ADDENDUM 5

BID TITLE: File No. 55-24 Green Road Pump Station

GREEN ROAD PUMP STATION– FILE NO. 55-24

DRAWN BY: SJT	SCALE: NTS	CWD NO:	SHEET NO:
DESIGNED BY: SJT	DATE: 12/2021		I-10
CHECKED BY: VM

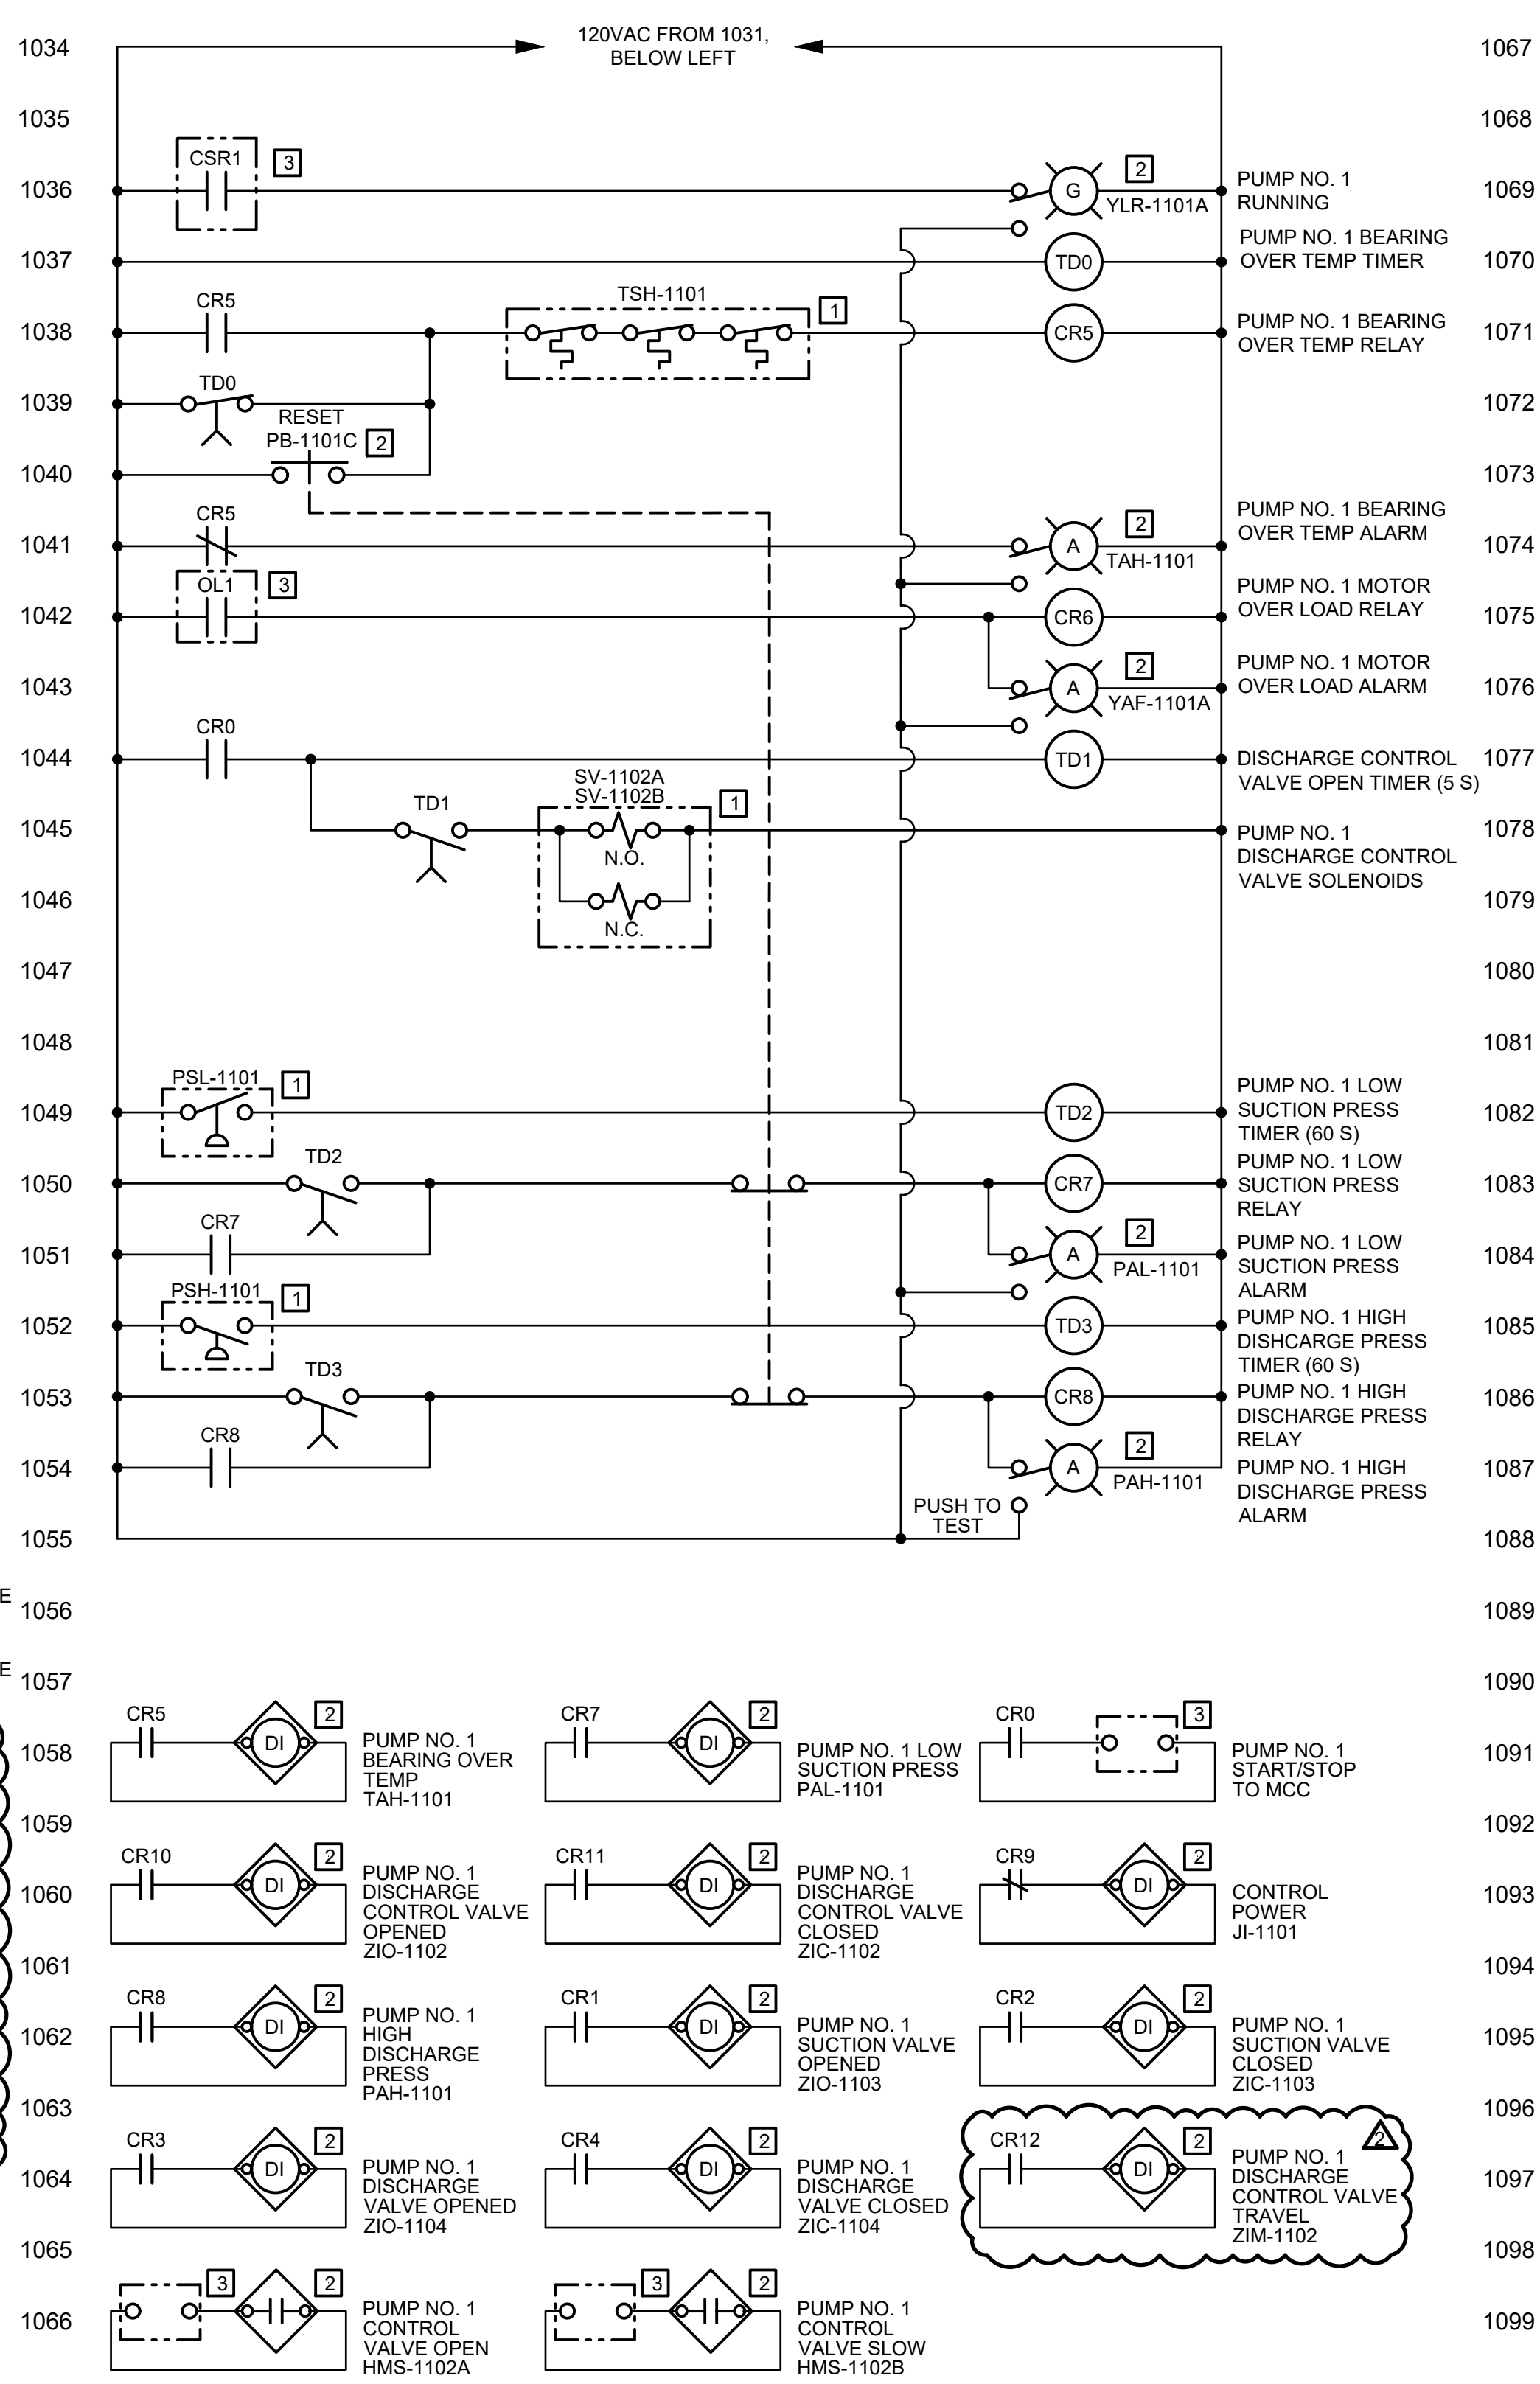
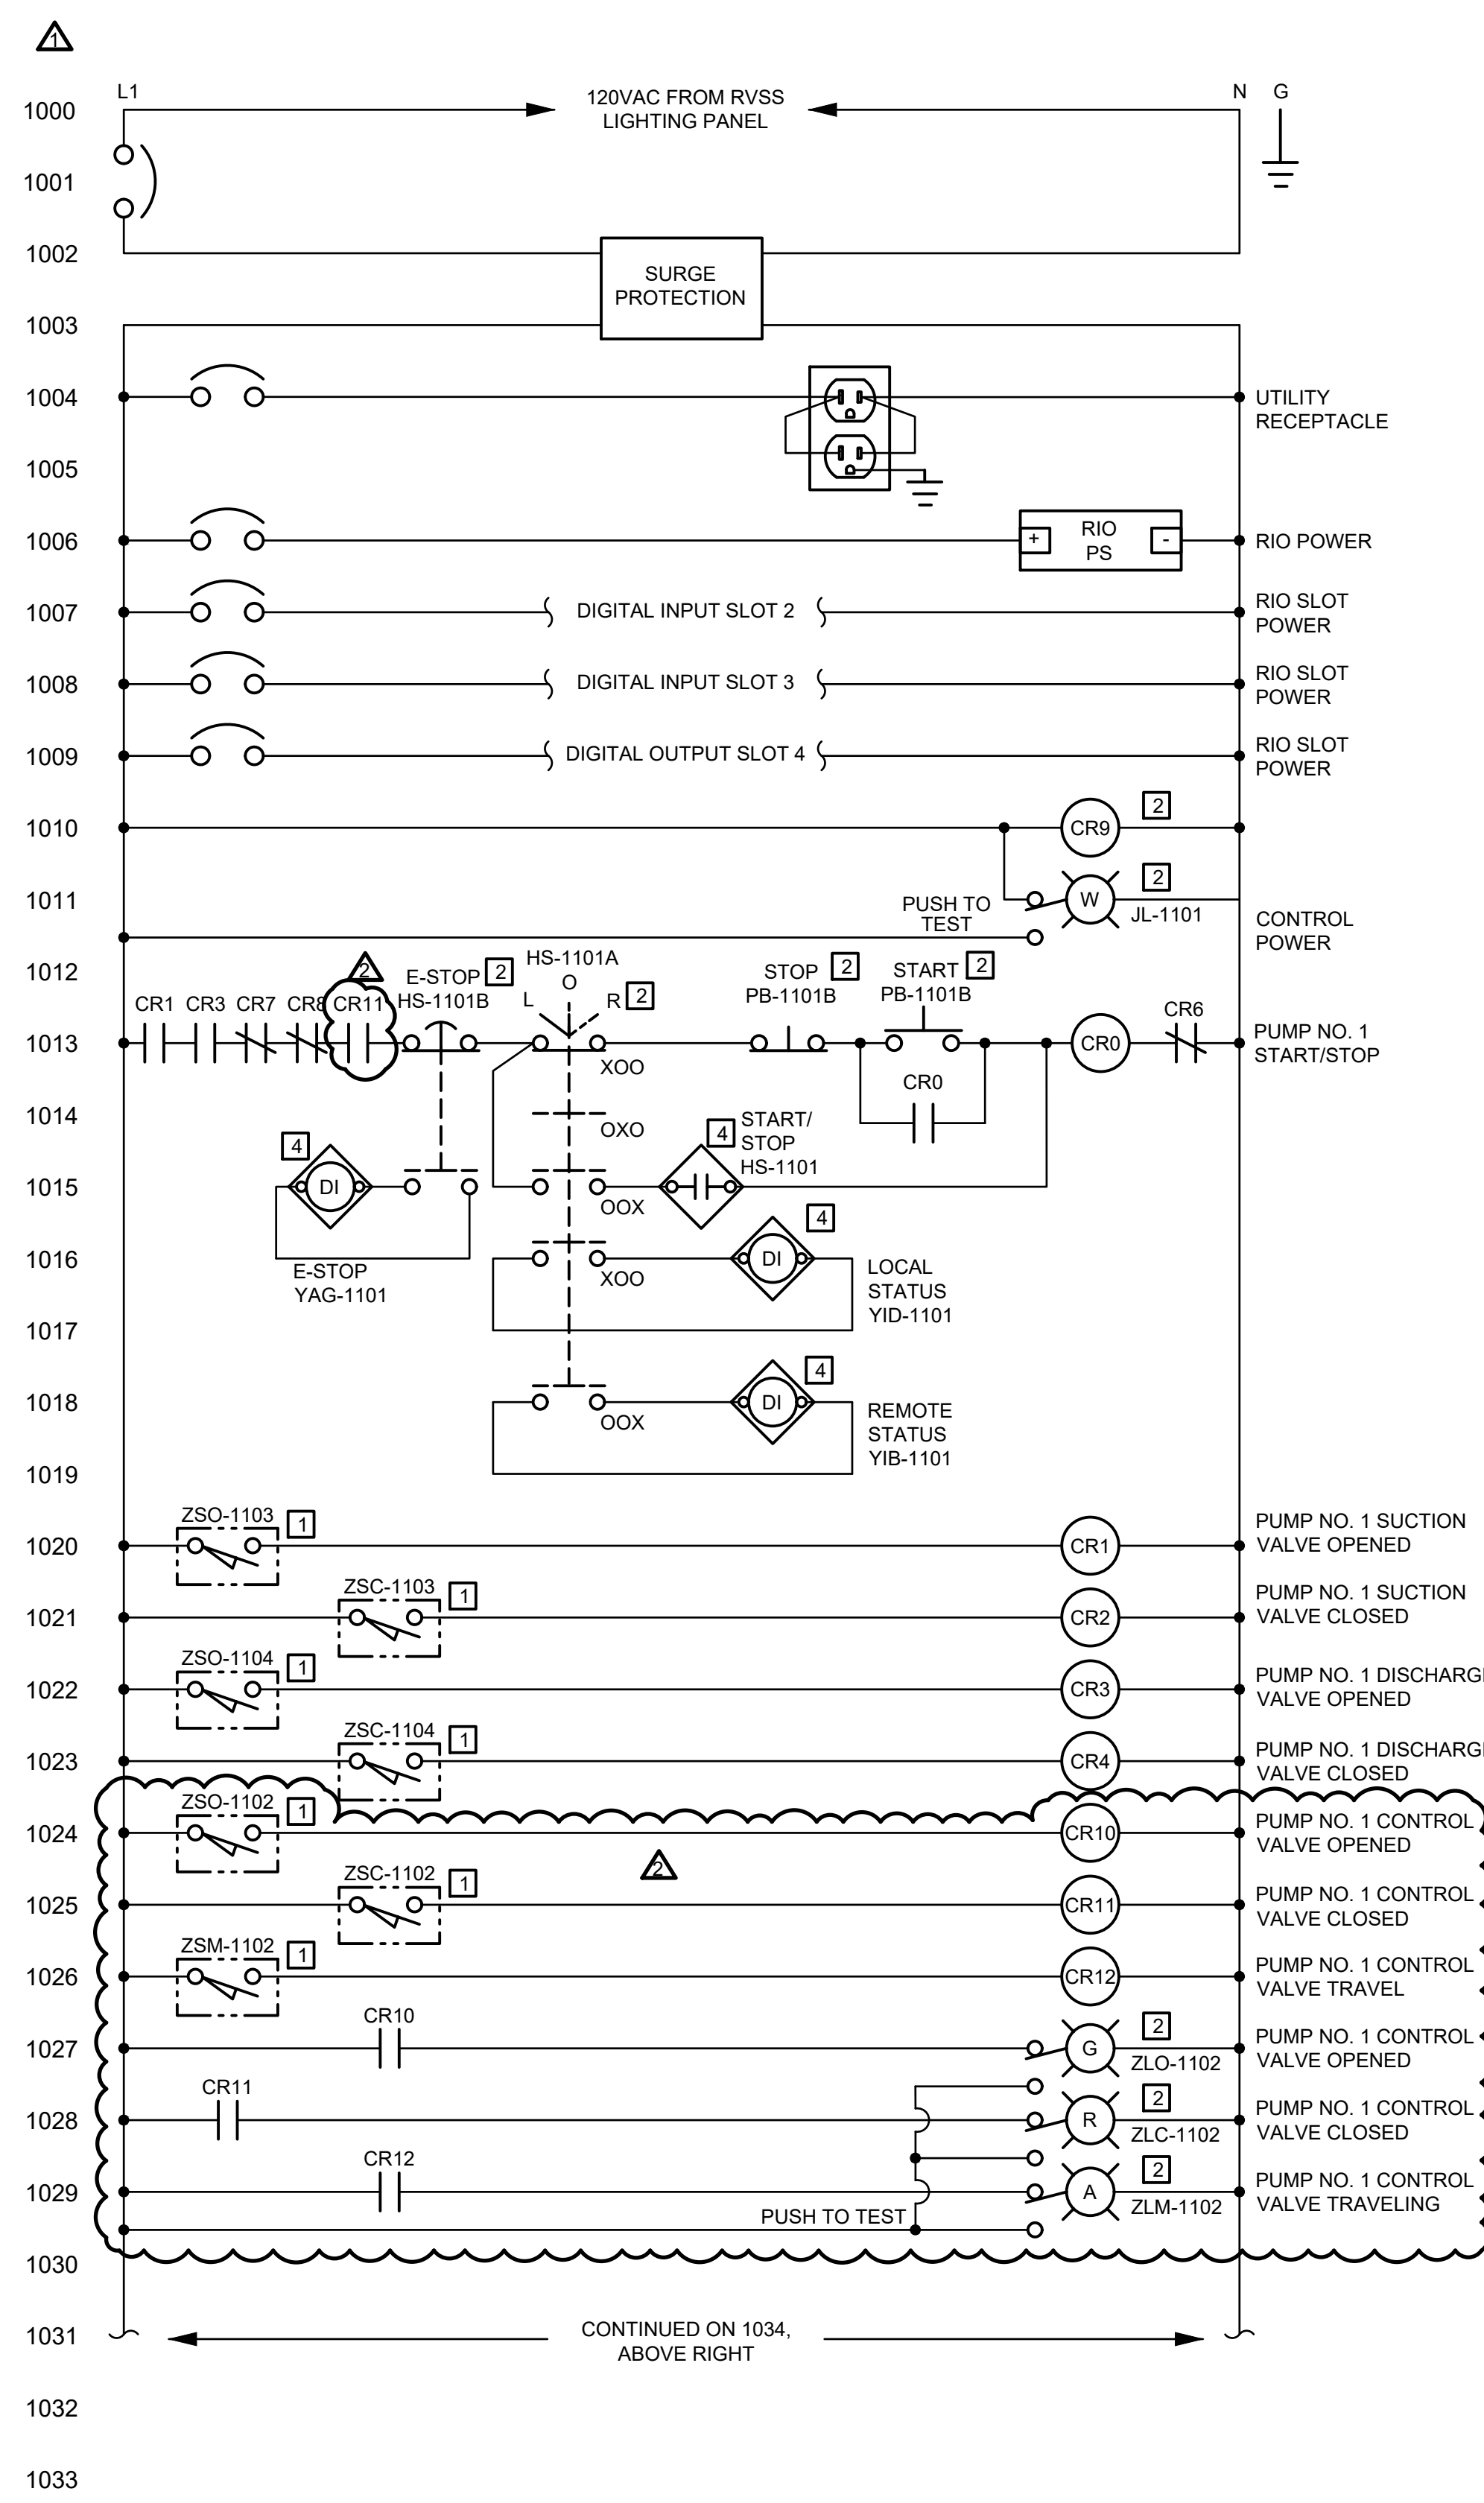
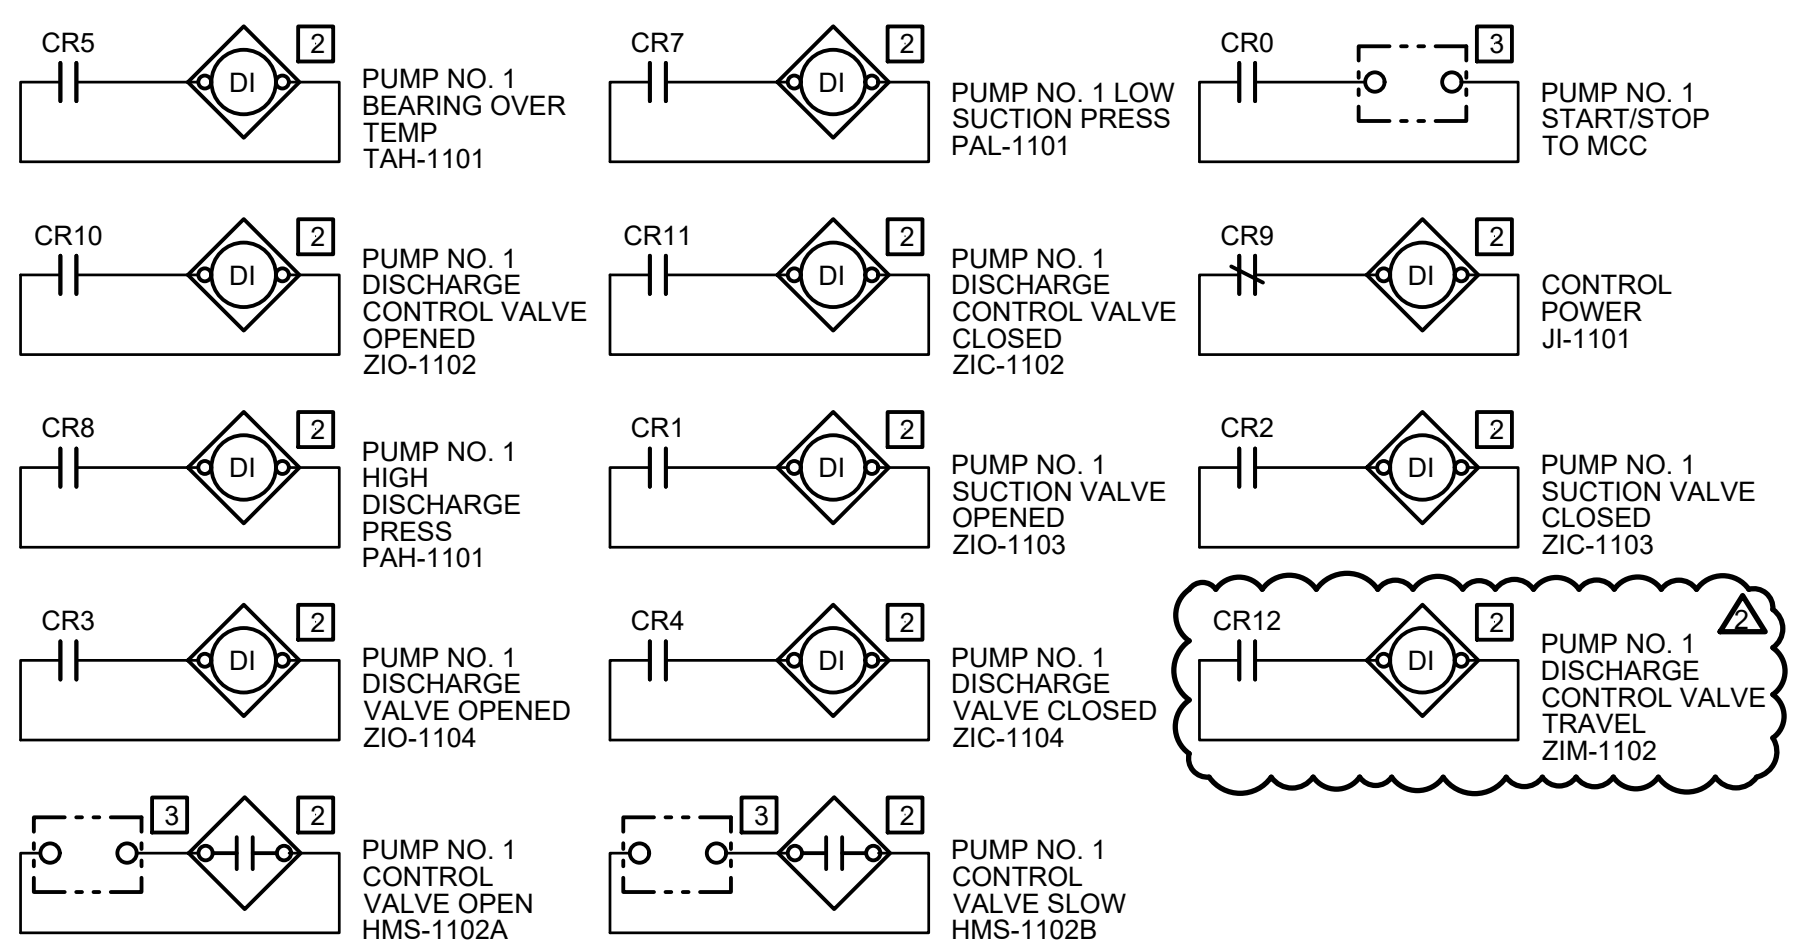
1. C-01 - Showing approximate routing of gas service.
2. C-03 - The gate detail was revised to reflect an ornamental security gate instead of a chain link gate, to match the rest of the existing gate.
3. I-05 thru I-10 and I-20 - Revised to include an intermediate position limit switch on the discharge check valves, and to include check valve closed as a start permissive for the pumps.
4. E-12 - Revised to add a CAT6 cable from each pump local control panel to the master control panel.

4. The ladder diagrams for the pump LCPs show two solenoids for operation of the hydraulic cylinders. Please provide additional detail on the purpose of each solenoid valve and their sequencing with ball check valve position and pump start/stop.

Answer: Ladder diagrams have been modified to add a relay indicating ball check valve closed position, and adding that relay as a start permissive for pump start.

Answer: Please see line 1044 of the schematic on sheet I-10. This shows the startup sequence for the pumps. After pump start, and following a 5-second timer, switch TD1 closes, powering both solenoids. The normally open solenoid closes and the normally closed solenoid opens, opening the discharge control valve (ball check valve).
